7.2 Reactor Protection (Trip) System (RPS)—Instrumentation and Controls

The information in this section of the reference ABWR DCD, including all subsections, tables and figures, is incorporated by reference with the following departures and supplements.

STD DEP T1 2.3-1 (Table 7.2-1, 7.2-2, Figures 7.2-2, 7.2-6, 7.2-9, 7.2-10)

Figure 7.2-2 Reactor Protection System Equipment Arrangement (From Sensors Through Trip Actuators)

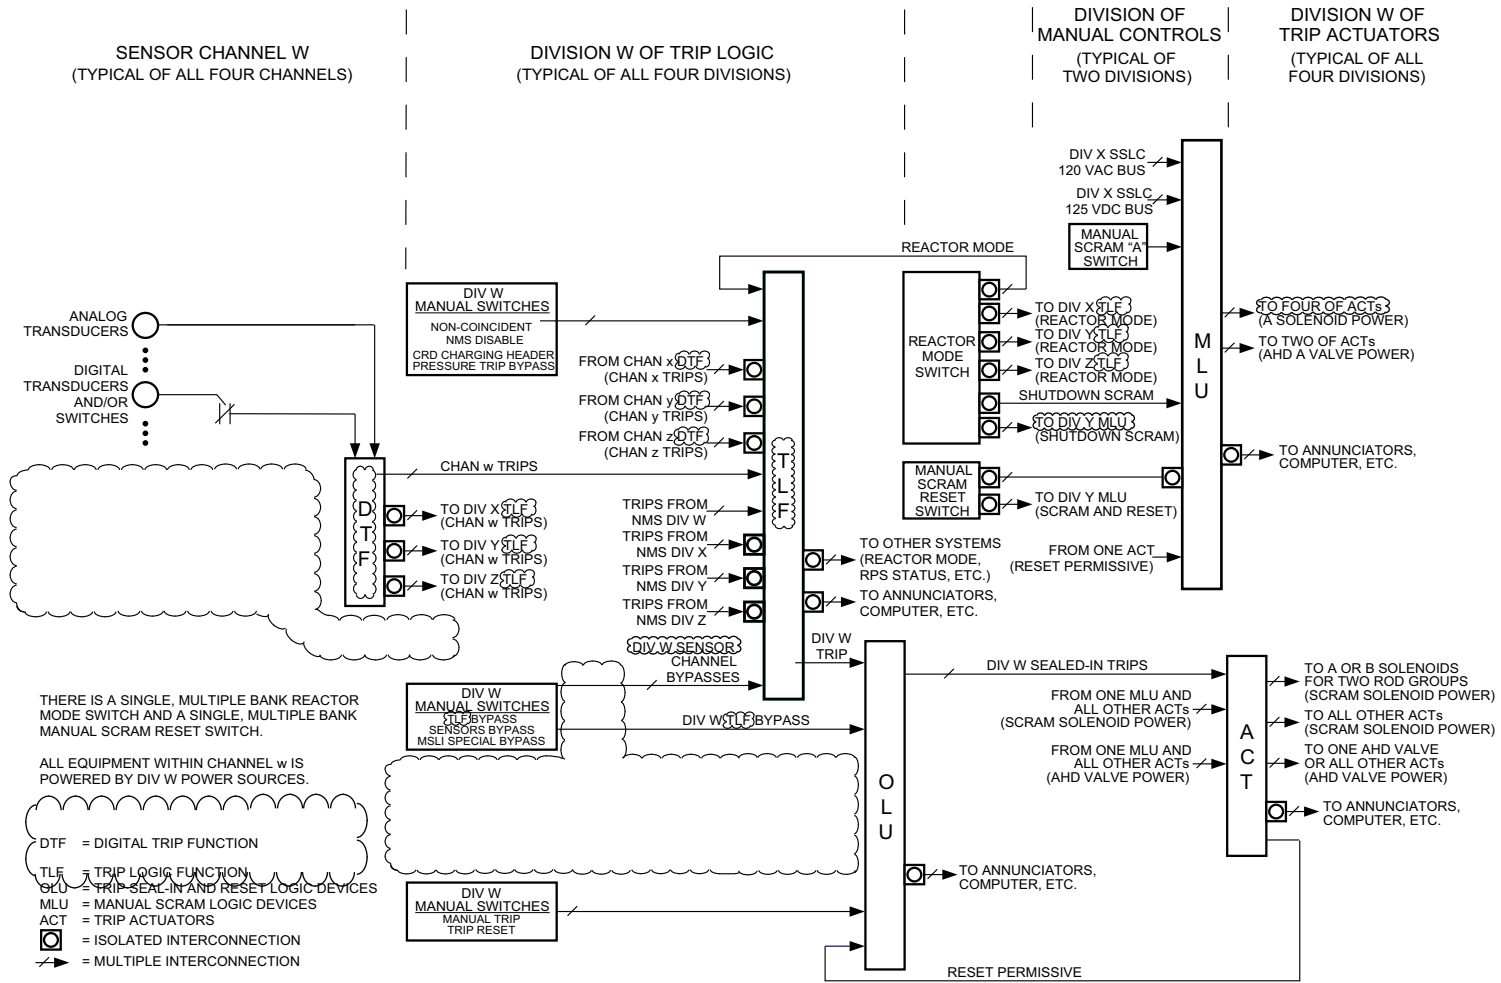
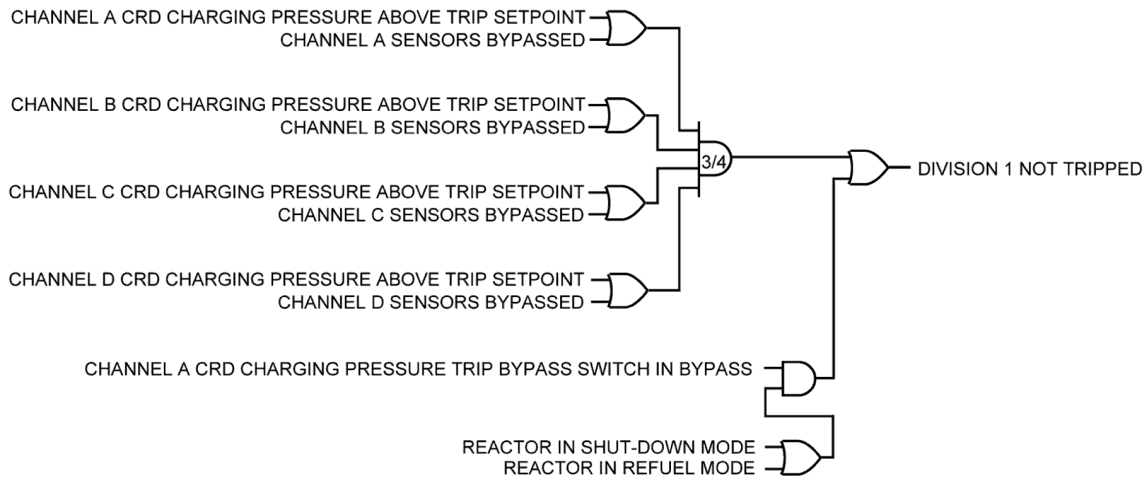
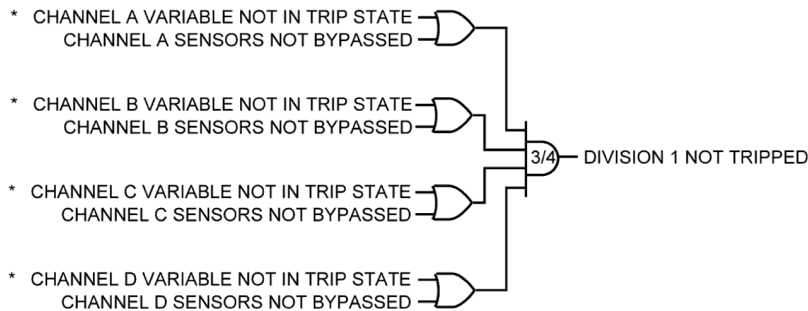
STD DEP T1 3.4-1 (Figures 7.2-2, 7.2-9, 7.2-10)

The RPS equipment is divided into four redundant divisions of sensor (instrument) channels, trip logics and trip actuators, and two divisions of manual scram controls and scram logic circuitry. The sensor channels, divisions of trip logics, divisions of trip actuators and associated portions of the divisions of scram logic circuitry together constitute the RPS scram and air header dump (backup scram) automatic initiation logic. The divisions of manual scram controls and associated portions of the divisions of scram logic circuitry together constitute the RPS scram and air header dump manual initiation logic. The automatic and manual scram initiation logics are independent of each other. RPS equipment arrangement is shown in Figure 7.2-2.
